TECHNICAL NOTE

EXISTING STANTON LANE ACCESS

21 SHAW LANE, MARKFIELD

project number: ADC1252			report reference: ADC1252-RP-A	
version	date	author	reviewer	comments
1		David Cummins		internal draft
2	30/10/2024	David Cummins	Akhila Martha	first issue to the client team
3	03/12/2024	David Cummins		minor amendment about switched gates

Figure 1: development layout, from the Transport Statement, showing the two accesses on Stanton Lane

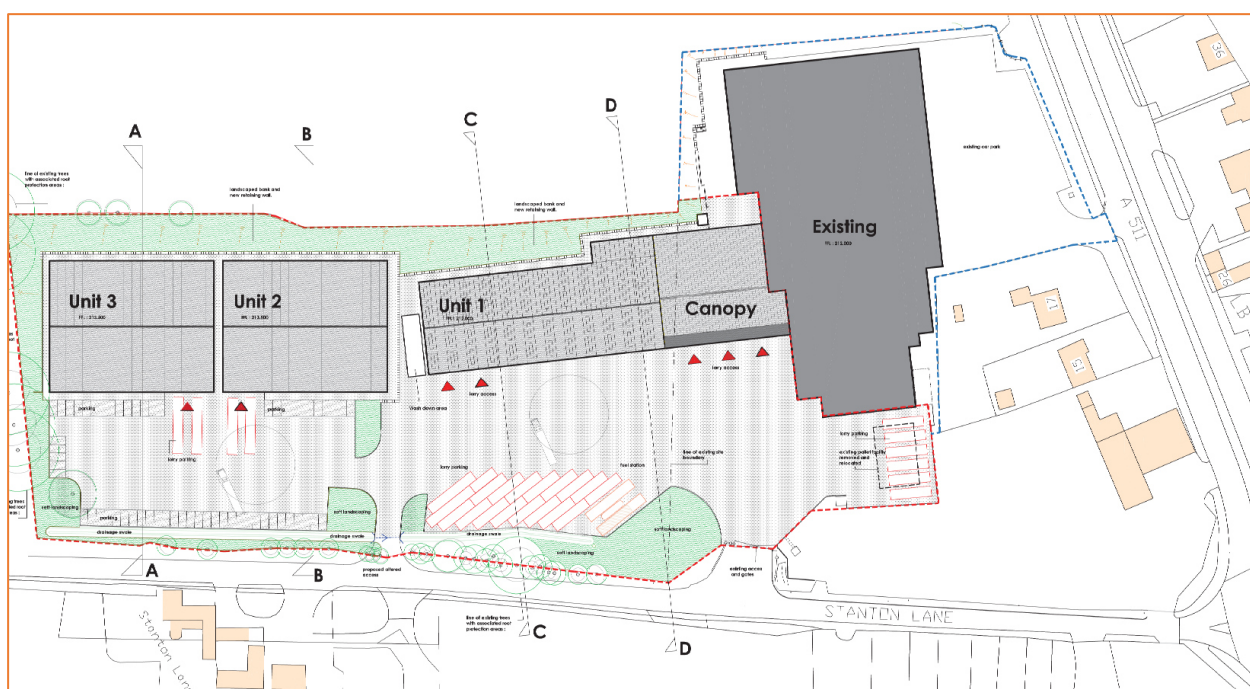
- 2.2 The existing Upton Steel service yard access on Stanton Lane was to be retained unchanged. A new (second) access was to be provided around 105m west of the existing access. Of the new access, paragraph 5.1 of the Transport Statement noted, “The site will be accessed via the creation of a new priority junction on Stanton Lane, as demonstrated by Drawing No. 22614_08_020_01 In accordance with DMRB TD 42/95 (paragraph 7.17b) the access will comprise a 7.3m wide access with 15m radii, and 1:10 tapers over a distance of 25m.”

- “The submitted HGV Tracking drawing MEC 22614_08_010_01 indicates HGVs will ‘overrun’ into the opposite carriageway at the new access, and also that this happens at the existing access, which has quite a restricted radii to the north. The LHA does not wish to see HGV vehicles overrunning into the opposite carriageway where it can be avoided, so would wish the accesses to be redrawn such that overrunning is negated / reduced. Albeit that the existing access is existing, the LHA also thinks that this could be improved by moving the access slightly to the south and thereby moving the centre line of the access, maybe by moving the pedestrian access gate to the north / opposite side of the access, or by remodelling the access slightly within the available red-line boundary i.e. removing the closeness to the restrictive radii to the north.*

1252 - ADC-ZZ-XX-DR- Z -0103

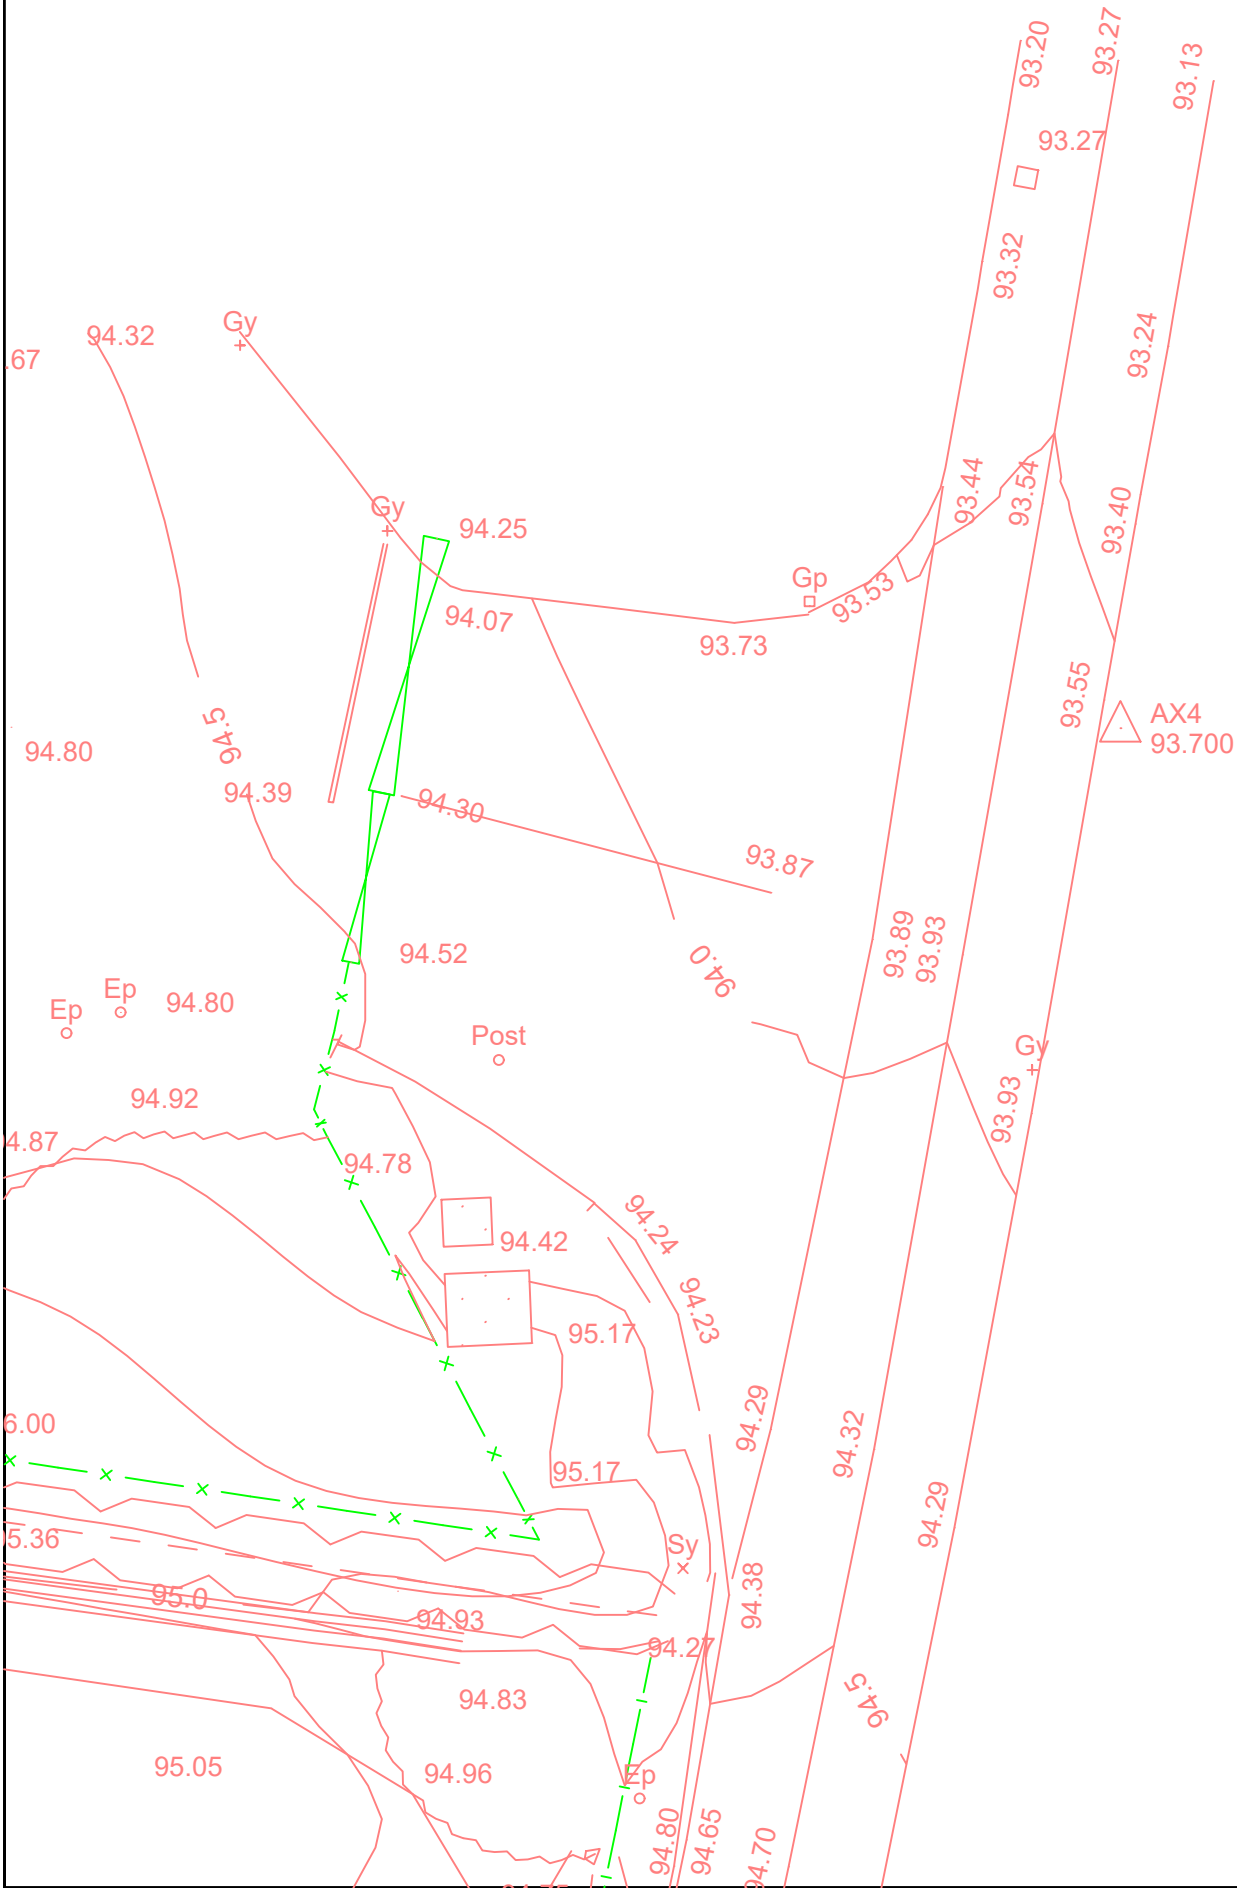
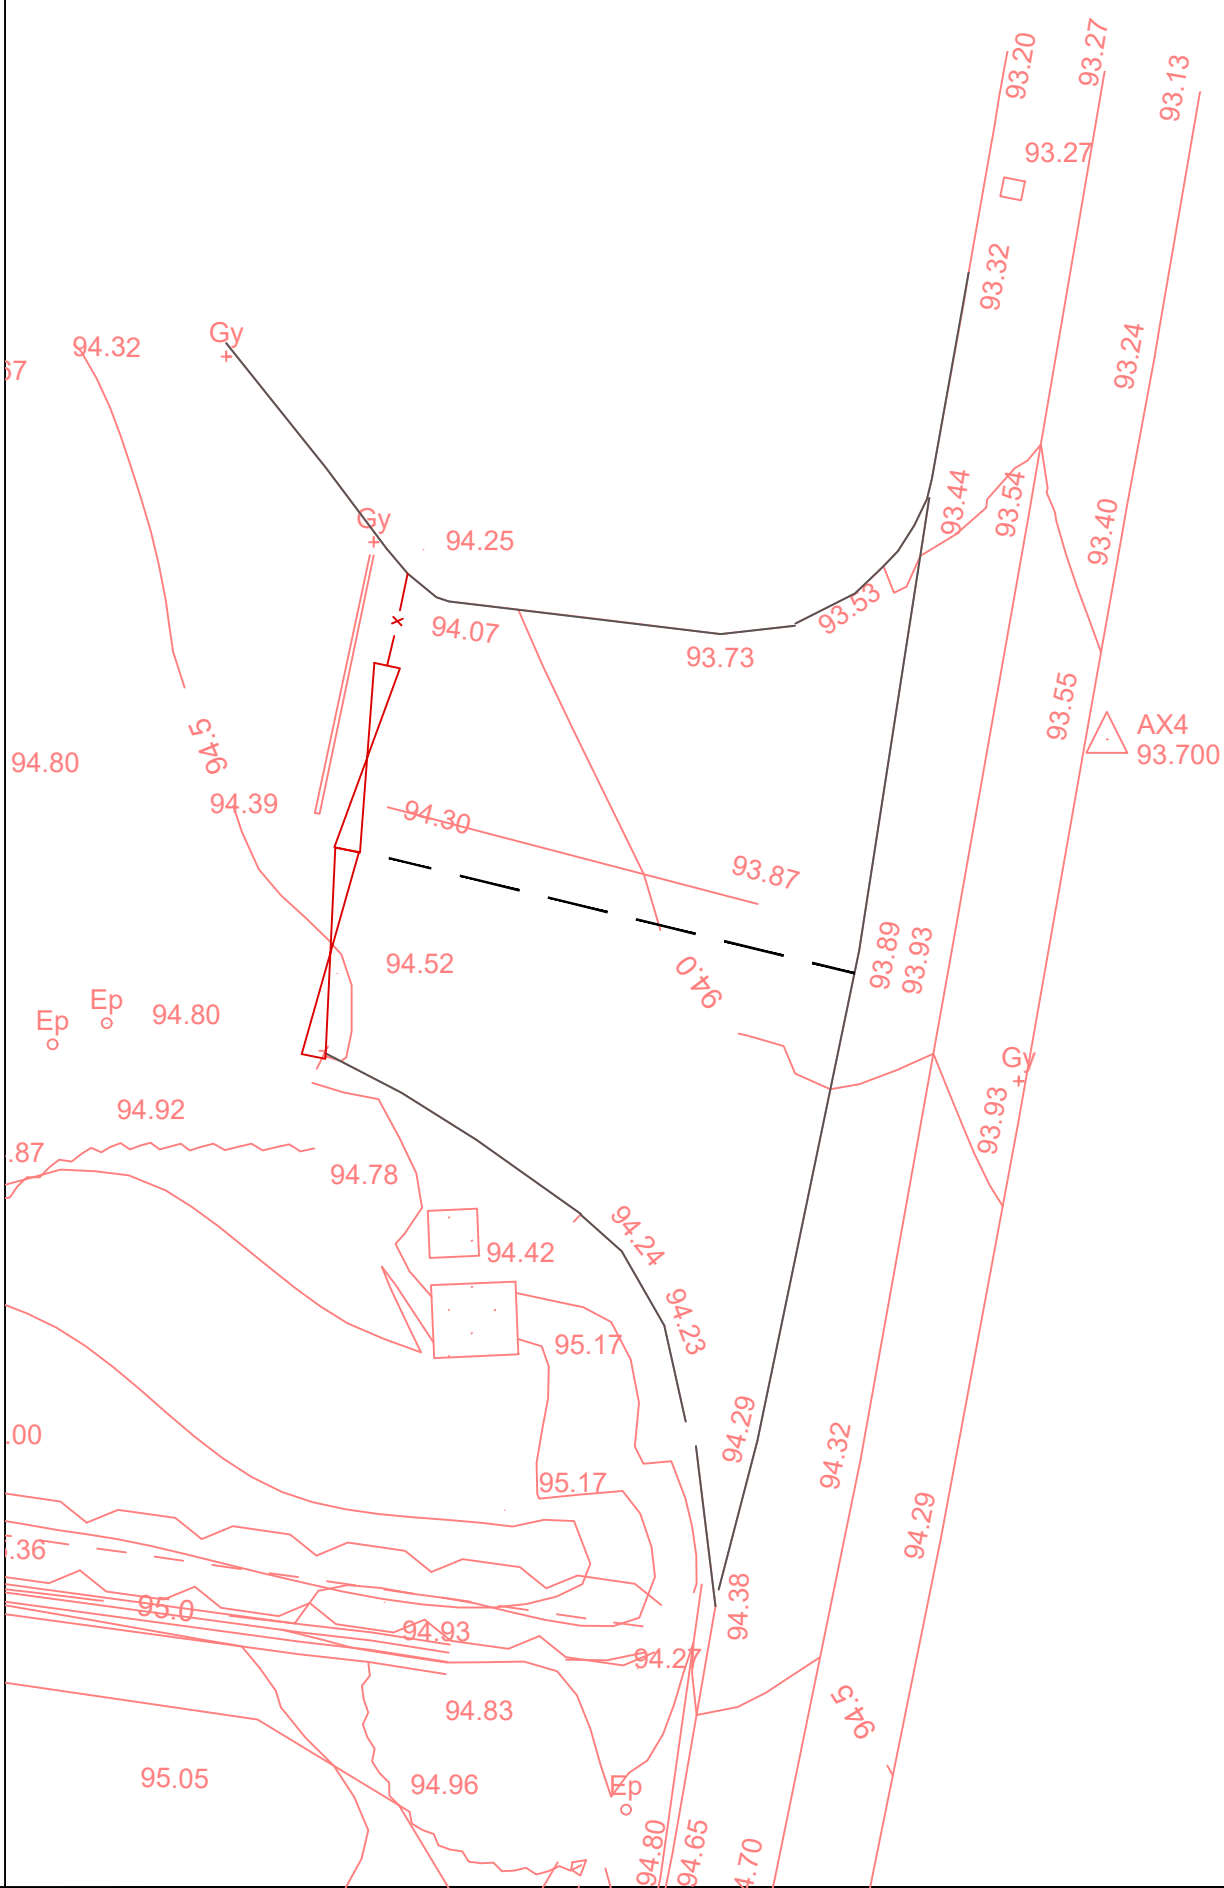
- 4.2 Upton Steel therefore propose to rehang the same gates, switched around as described above. The works are shown on **Drawing 1252-ADC-ZZ-XX-DR-Z-0103-S1-P01**, and can be secured by a revised condition.

- 5.5 Despite that, Upton Steel will rehang the existing gates, moving the pedestrian access to the north and realigning the vehicle centreline southwards. The proposed works are shown on **Drawing 1252-ADC-ZZ-XX-DR-Z-0103-S1-P01** and can be secured by condition. Retaining the existing bellmouth area, and not reducing it, will provide additional space for HGVs to turn left. Changing the gates would more than mitigate the marginal increase in risk from a marginal increase in the number of HGVs turning left out of the existing access.

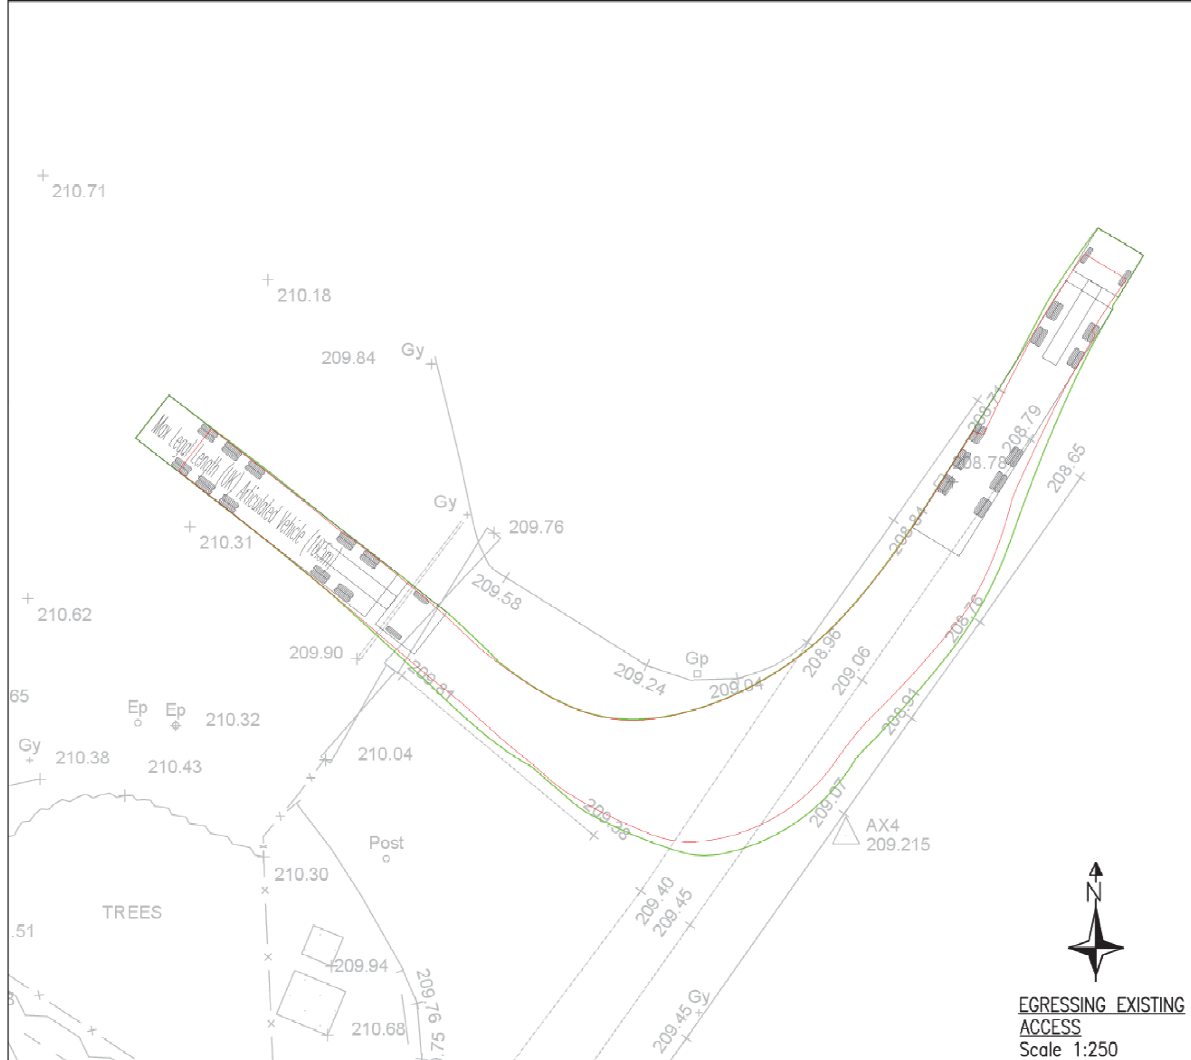
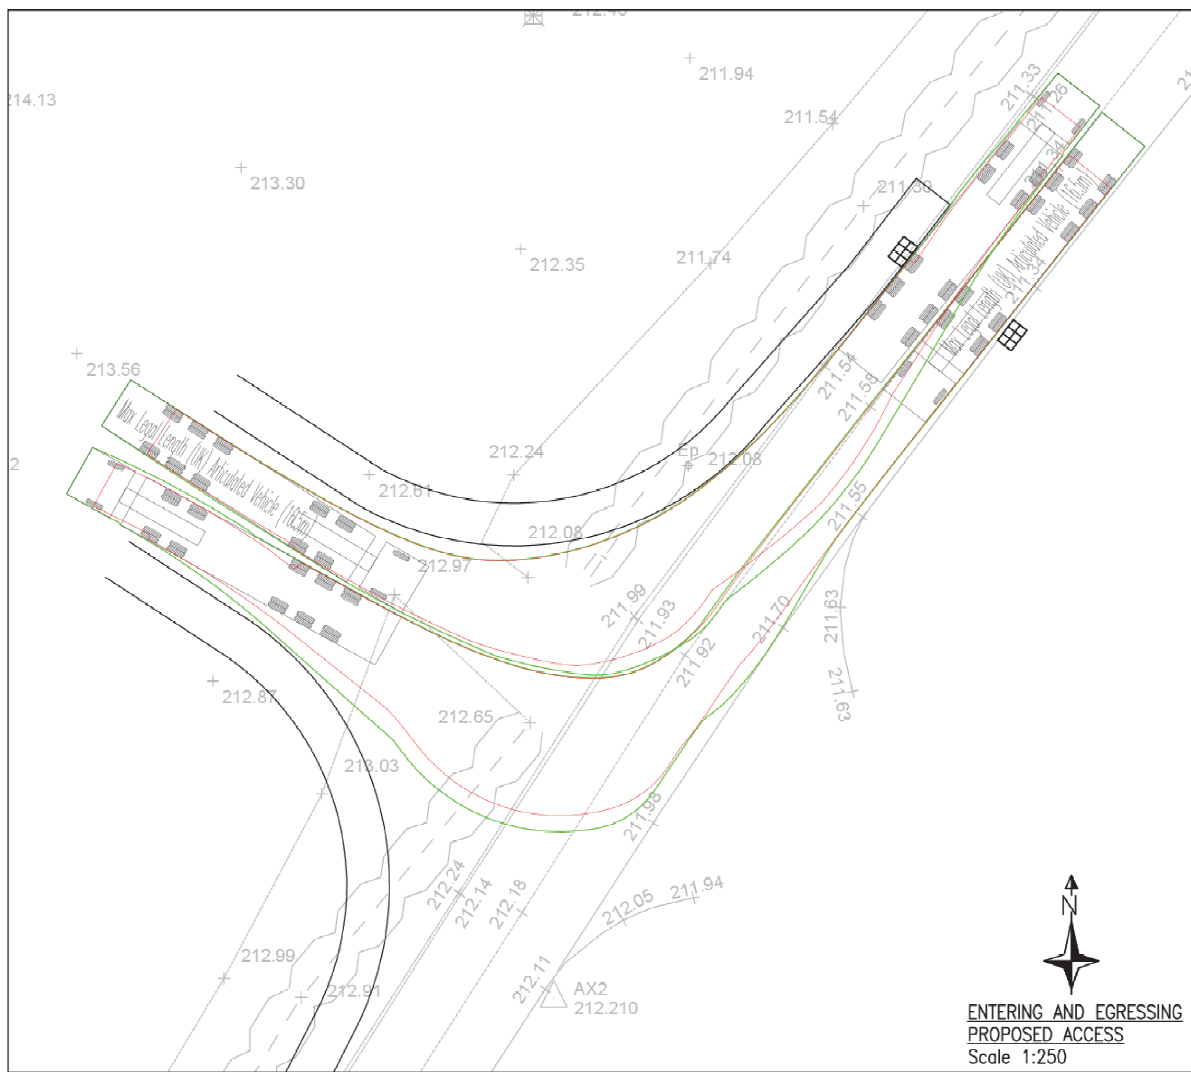
The submitted HGV Tracking drawing MEC 22614_08_010_01 indicates HGVs will 'overrun' into the opposite carriageway at the new access, and also that this happens at the existing access, which has quite a restricted radii to the north. The LHA does not wish to see HGV vehicles overrunning into the opposite carriageway where it can be avoided, so would wish the accesses to be redrawn such that overrunning is negated / reduced. Albeit that the existing access is existing,

The LHA require new access drawing(s) that show no/reduced 'overrunning' into the opposite carriageway at both accesses; or the one remaining access.
